CENTERVILLE CITY PLANNING COMMISSION AGENDA

Short Title: ADMINISTRATIVE DECISION - Public Hearing - Preliminary Subdivision & Final Site Plan - The Lane

Review Preliminary Subdivision and Final Site Plan submittals for twelve unit Residential-Medium project located at approximately 644 West Porter Lane.

Site Plan

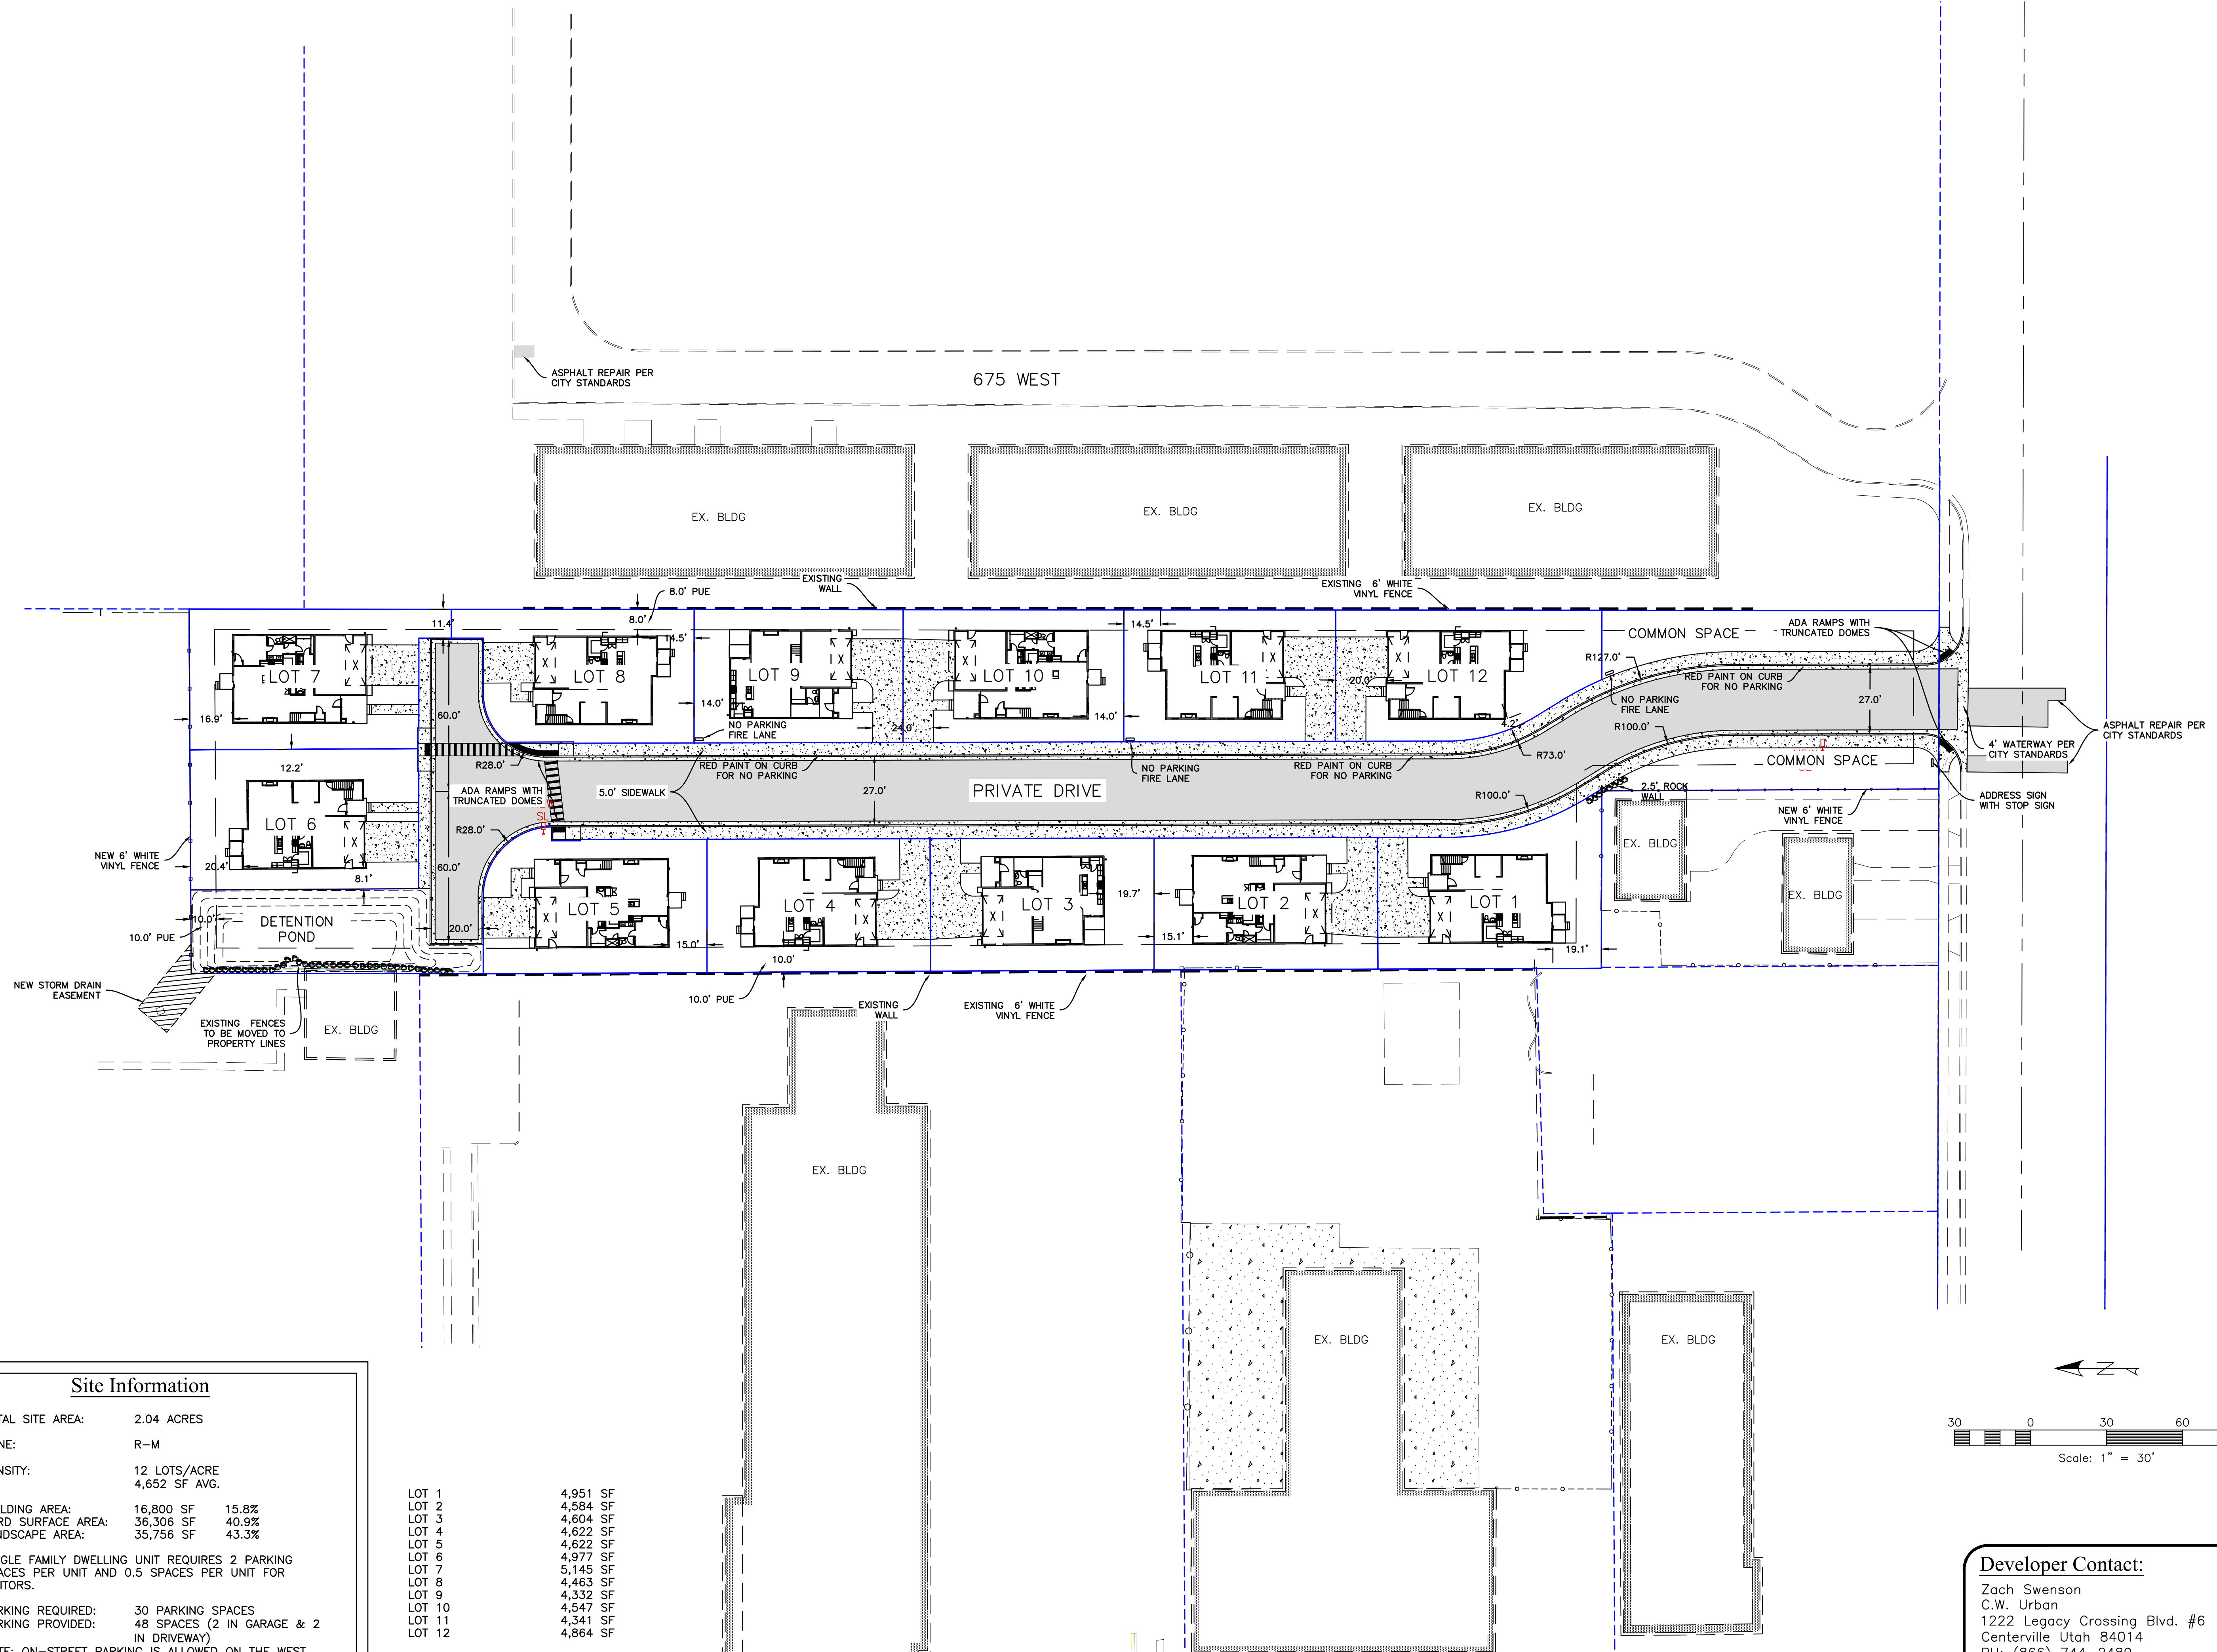
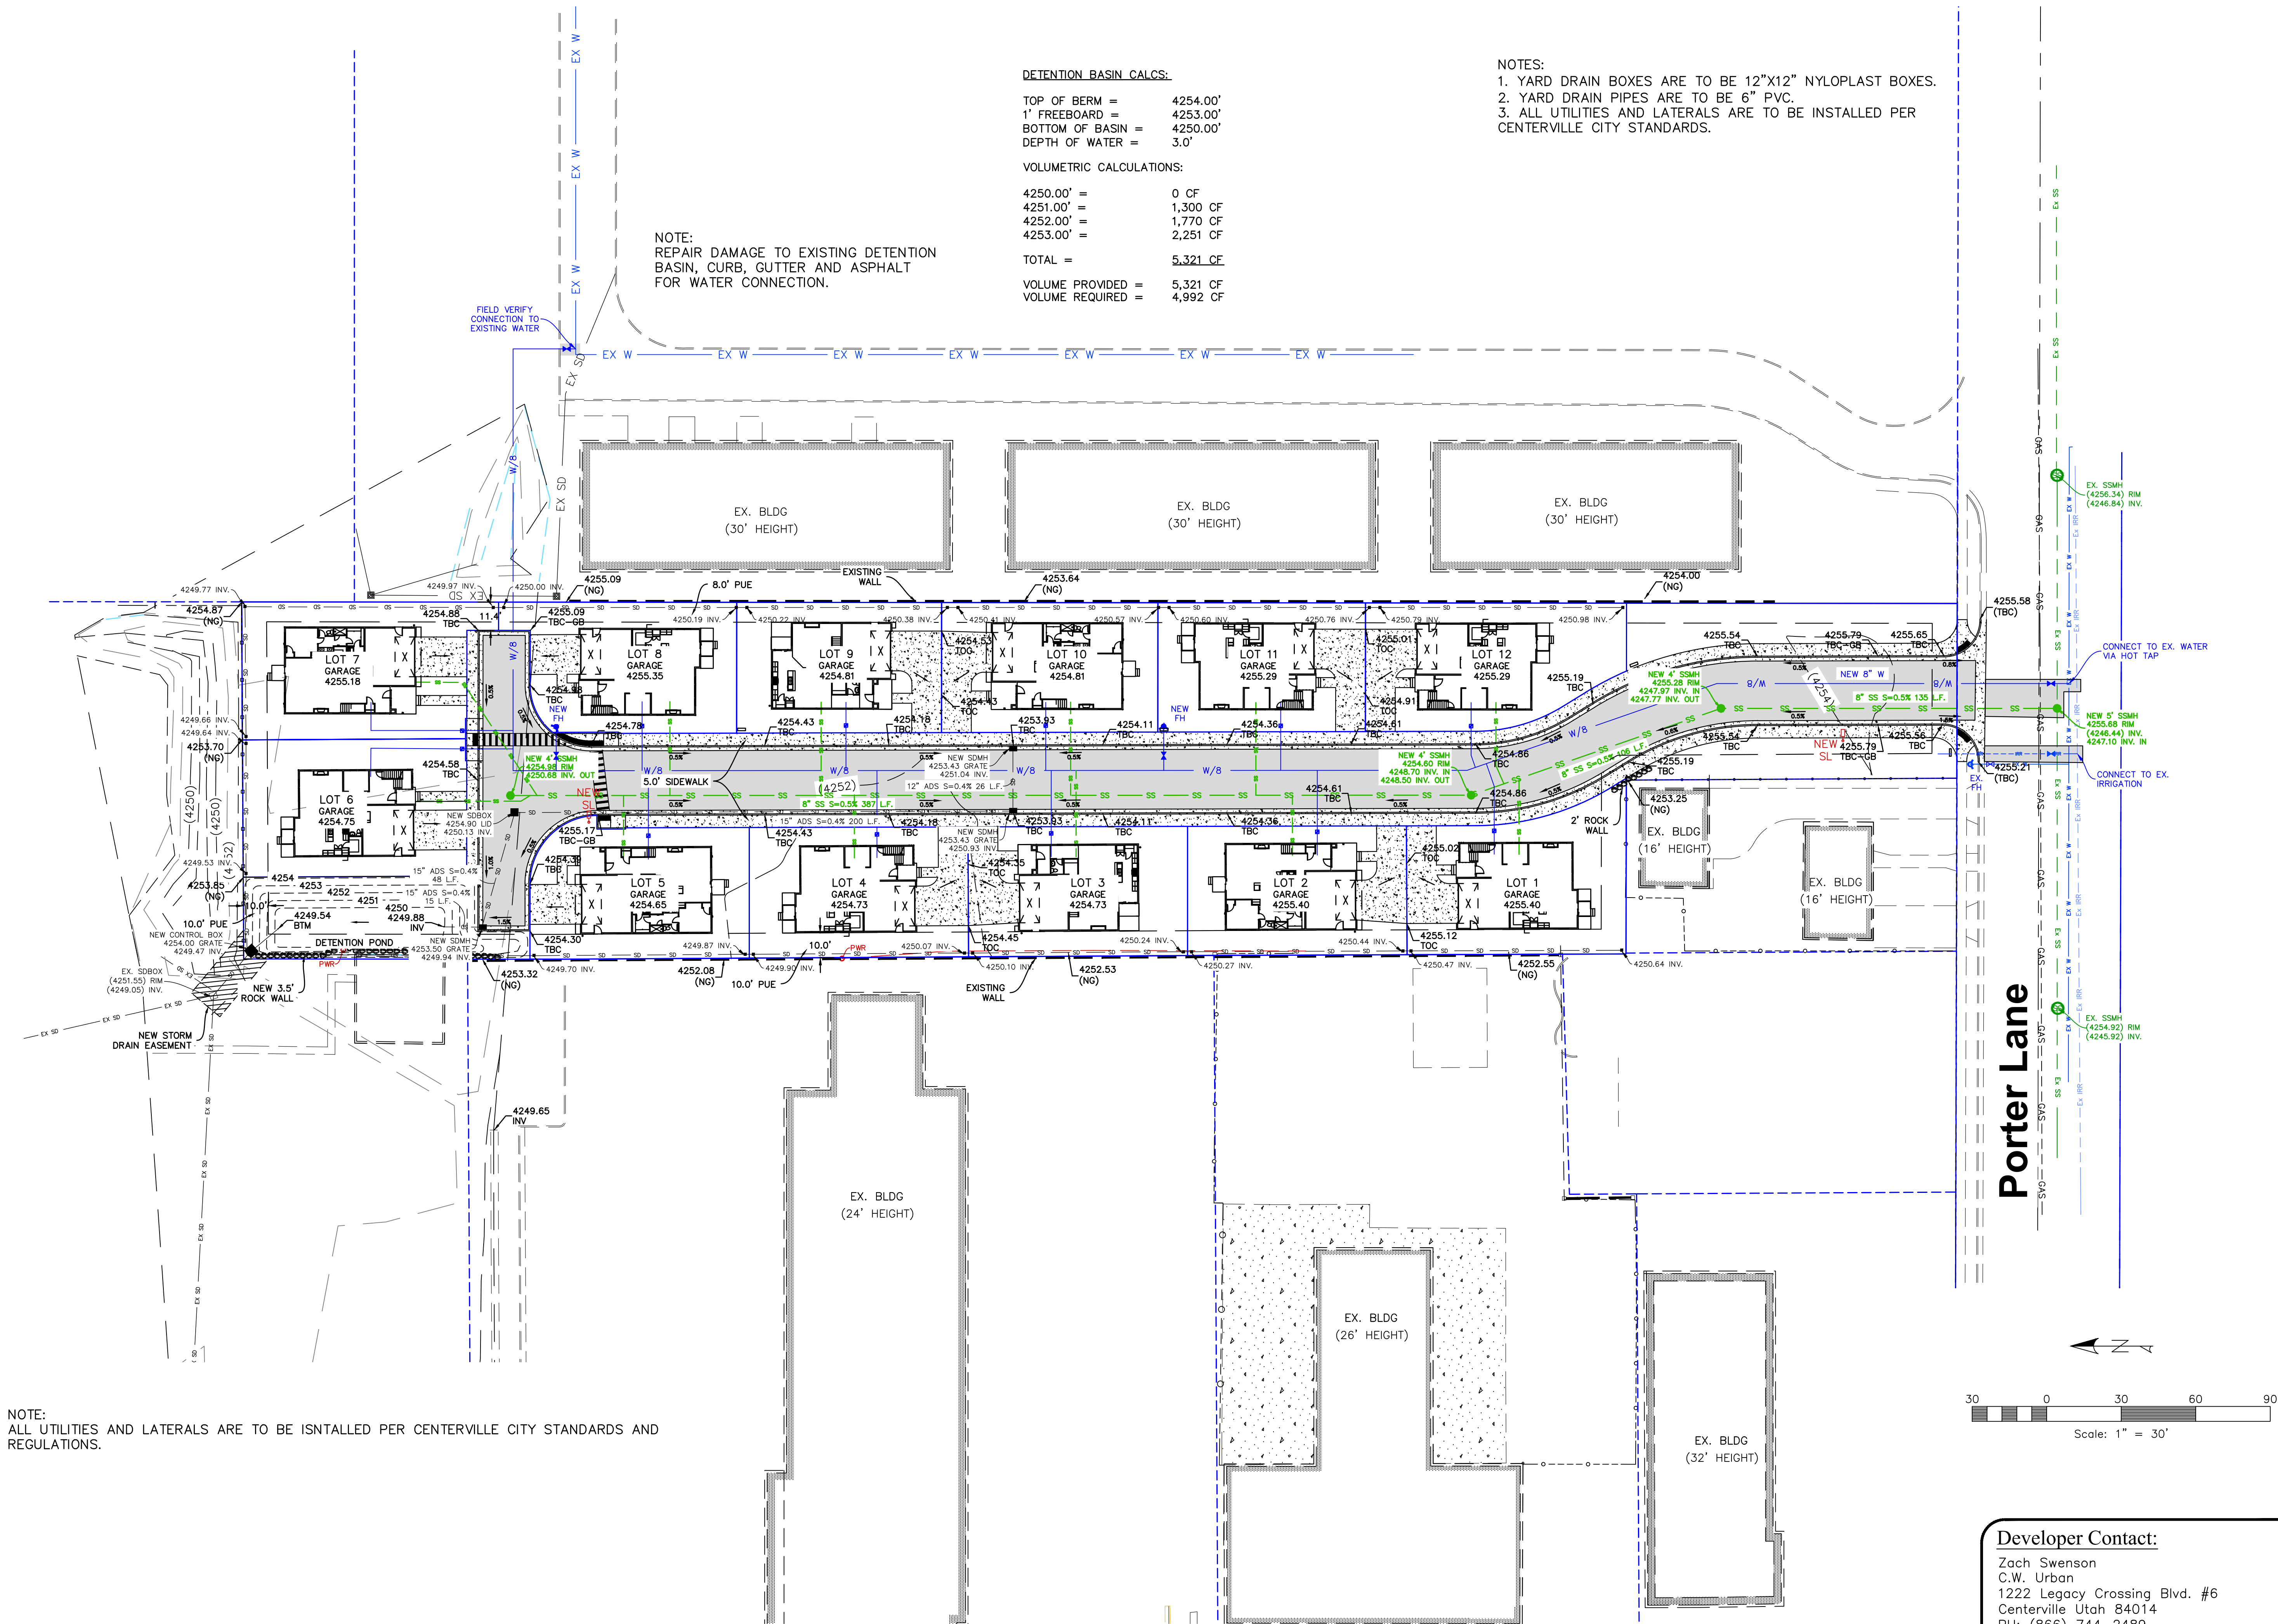
The dwelling on Lot 7 will need to be shifted south in order to comply with CZC 12.32.300. However, the adjustment of the eastern setback is in compliance with code and Staff believes it substantially conforms to the conceptual plan.

Staff Response: The current road width does not meet City Standards and will need to be widened to meet the required 27-feet of travel lane, i.e. pavement.

Staff Response: As is, the proposal meets this requirement. However, as stated in the Final Site Plan review, the pavement (or asphalt) width is not the required 27 feet. The road will need to be widened to come into compliance.
